DIXON AND HUGHEY SUBDIVISION

APPLICATION NUMBER 2 DATE June 18, 2020

DETAIL SITE PLAN

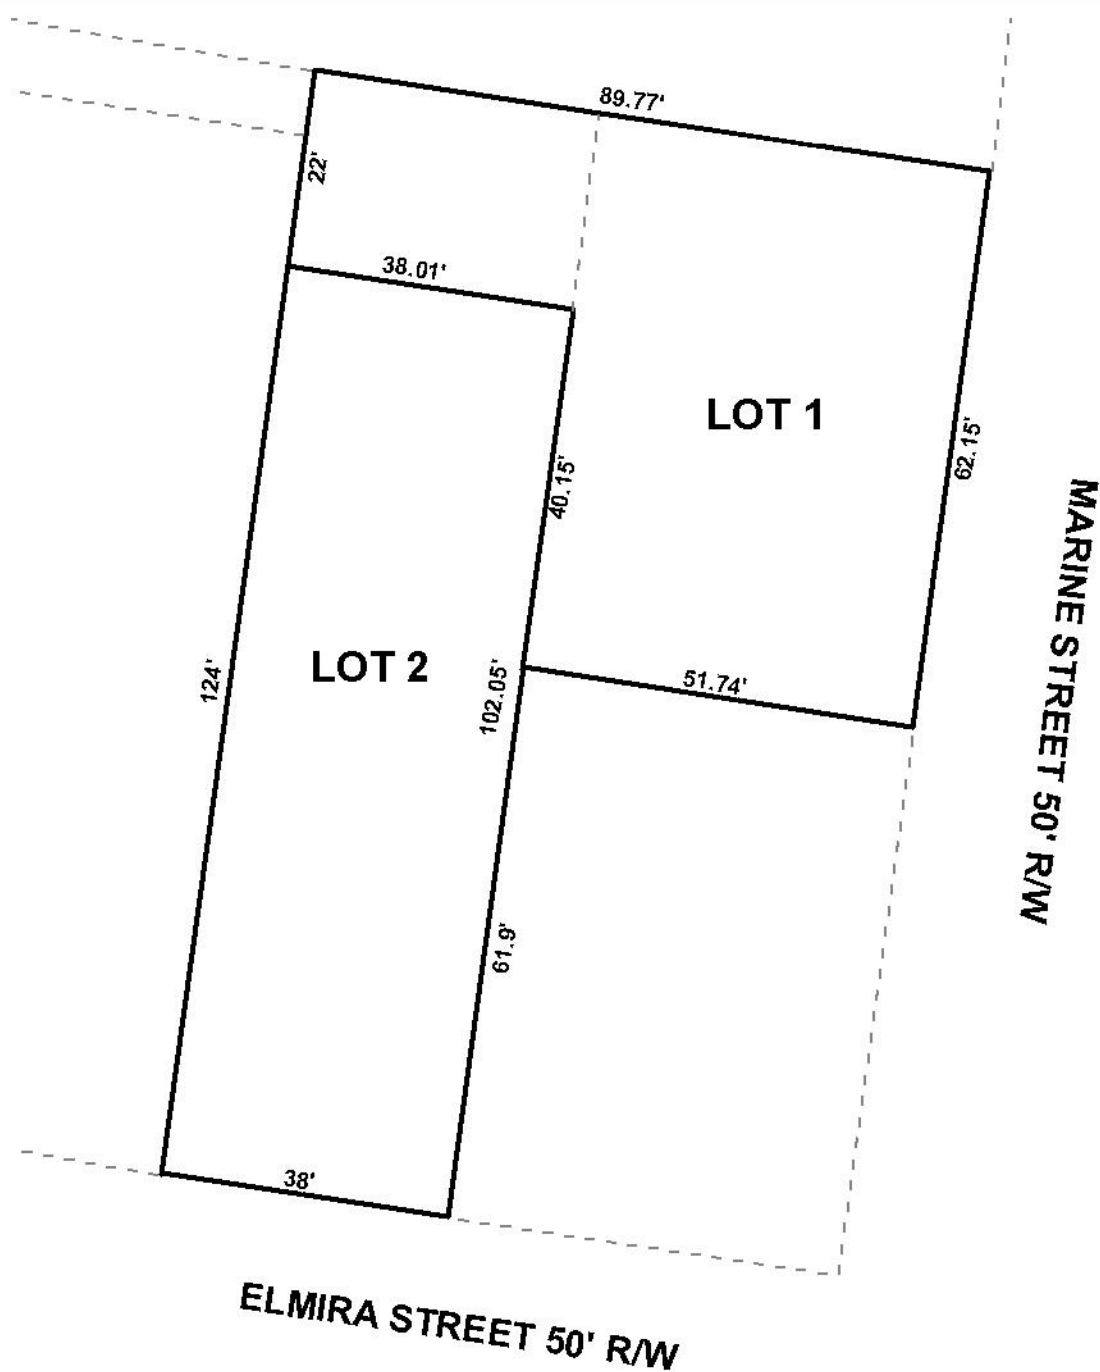
As proposed, Lot 1 has frontage along Marine Street and Lot 2 has frontage along Elmira Street. Both are minor streets with curb and gutter and are illustrated showing compliant rights-of-way. It should be noted that no setbacks are depicted on the preliminary plat submitted. Since the site is located within a historic district, relief from the normal building setbacks and site coverage limitation is automatically granted via the more flexible Historic District Overlay under Section 64-3.G. of the Zoning Ordinance. Therefore, it is recommended that Section V.D.9. of the Subdivision Regulations be waived, and that a note be placed on the Final Plat stating that all setbacks shall be determined by Section 64-3.G. Historic District Overlay requirements of the Zoning Ordinance.

As illustrated, neither proposed lot will meet the minimum area requirement of 7,200 square feet as detailed in Section V.D.2. of the Subdivision Regulations. Additionally, Lot 2 illustrates a sub-standard lot width of 38 feet at the building setback line. However, as sub-standard sized lots are common in the vicinity and within historic districts, a waiver of Section V.D.2. could be appropriate. If approved, the lot size label should be retained in both square feet and acres on the Final Plat, or a table should be furnished on the Final Plat providing the same information.

No easements are indicated on the preliminary plat. If any easements are recorded on the site they should be indicated and labeled on the Final Plat, and a note should be placed on the Final Plat stating that no structure may be placed or constructed within any easement.

- 1) placement of a note on the Final Plat stating that all setbacks shall be determined by Section 64-3.G. Historic District Overlay requirements of the Zoning Ordinance;
- 2) retention of the lot size in both square feet and acres, or the furnishing of a table on the Final Plat providing the same information, adjusted for dedication;

- 3) placement of a note on the Final Plat stating that no structure may be constructed or placed within any easement, if applicable;
- 4) compliance with the Engineering comments: (FINAL PLAT COMMENTS *(should be addressed prior to submitting the FINAL PLAT for review and/or signature by the City Engineer)*): A. Provide all of the required information on the SUBDIVISION PLAT (i.e. signature blocks, signatures, certification statements, written legal description, required notes, legend, scale, bearings and distances) that is required by the current Alabama State Board of Licensure for Professional Engineers and Land Surveyors. B. Provide reference, on the map and the description, to a monumented corner. C. Show and label the POC and POB. D. Label all lines shown on the drawing, or add them to the legend. E. Show and label all flood zones. F. Show and label the MFFE (Minimum Finished Floor Elevation) on each lot that contains an AE, V, or X (shaded) flood zone designation. G. Correct the names of the Owners listed in the Owner's signature block. H. Provide the Surveyor's, Owner's (notarized), Planning Commission, and Traffic Engineering signatures. I. Add a note to the SUBDIVISION PLAT stating that as shown on the 1984 aerial photo (FLIGHT 29 - #77) LOTS 1 and 2 will receive historical credit of existing (1984) impervious area towards stormwater detention requirement per Mobile City Code, Chapter 17, Storm Water Management and Flood Control) as follows: LOT 1 – 1,200 sf and LOT 2 – 1,200 sf. J. Add a note to the SUBDIVISION PLAT stating that a Land Disturbance permit will be required for any land disturbing activity in accordance with Mobile City Code, Chapter 17, Storm Water Management and Flood Control; the City of Mobile, Alabama Flood Plain Management Plan (1984); and, the Rules For Erosion and Sedimentation Control and Storm Water Runoff Control. K. Add a note to the Plat stating that the approval of all applicable federal, state, and local agencies (including all storm water runoff, wetland and floodplain requirements) will be required prior to the issuance of a Land Disturbance permit. L. Add a note that sidewalk is required to be constructed, and/or repaired, along the frontage of each lot, or parcel, at time of new development or construction, unless a sidewalk waiver is approved. M. Add a note to the plat stating that all proposed detention facilities, common areas, and wetlands shall be the responsibility of the Property Owner(s), and not the responsibility of the City of Mobile. N. Add a note to the plat stating that all easements shall remain in effect until vacated through the proper Vacation process. O. Provide a copy of the FINAL SUBDIVISION PLAT and LETTER OF DECISION to the Engineering Dept. for review. No signatures are required on the drawing. Place the information for the Subdivision Plat on the PLAT Review sign-in sheet. P. After addressing all of the FINAL SUBDIVISION PLAT review comments provide the red-line markup, the ORIGINAL (with all other signatures) and one (1) copy of the revised original (signatures not required) of the revised Final Plat to the Engineering Department. Place the information for the Subdivision Plat on the PLAT Review sign-in sheet.);
